AGREEMENT CONCERNING THE ADOPTION OF UNIFORM TECHNICAL
PRESCRIPTIONS FOR WHEELED VEHICLES, EQUIPMENT AND PARTS WHICH
CAN BE FITTED AND/OR BE USED ON WHEELED VEHICLES AND THE
CONDITIONS FOR RECIPROCAL RECOGNITION OF APPROVALS GRANTED ON
THE BASIS OF THESE PRESCRIPTIONS
DONE AT GENEVA ON 20 MARCH 1958

AMENDMENTS PROPOSED TO REGULATION NO. 48

TRANS/WP.29/624
2 June 1998

DRAFT 02 SERIES OF AMENDMENTS TO REGULATION No. 48

6.5.5.2. or, at the discretion of the manufacturer, for M₁ category vehicles (**):

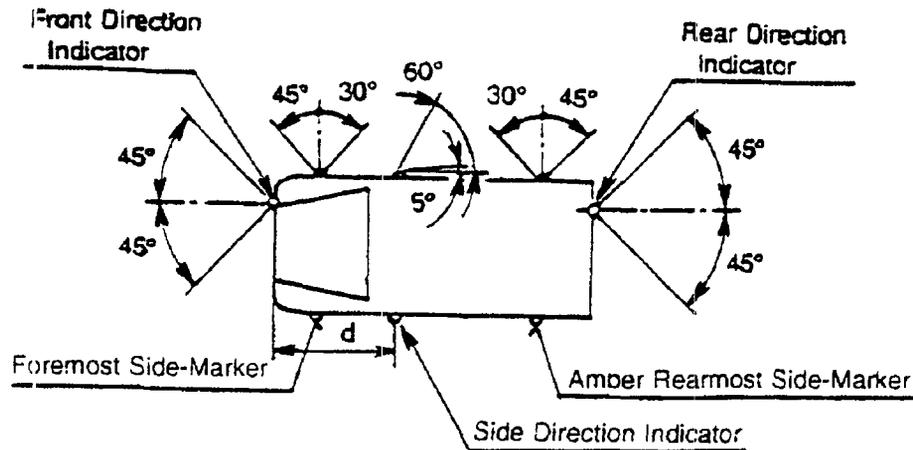
Paragraph 6.5.5., related to Direction Indicator Lamp, amend to read:

Front and rear direction-indicator lamps, as well as side-marker lamps
Horizontal angles see figure below:

(**) The value of 5° given for the dead angle of visibility to the rear of the side direction-indicator is an upper limit

$$d \leq 2.50 \text{ m}$$

Vertical angles: 15° above and below the horizontal. The vertical angle below the horizontal may be reduced to 5° if the lamps are less than 750 mm above the ground.

To be considered visible, the lamp must provide an unobstructed view of the apparent surface of at least 12.5 square centimetres, except for side direction-indicators of categories 5 and 6. The illuminating surface area of any retro-reflector that does not transmit light shall be excluded."
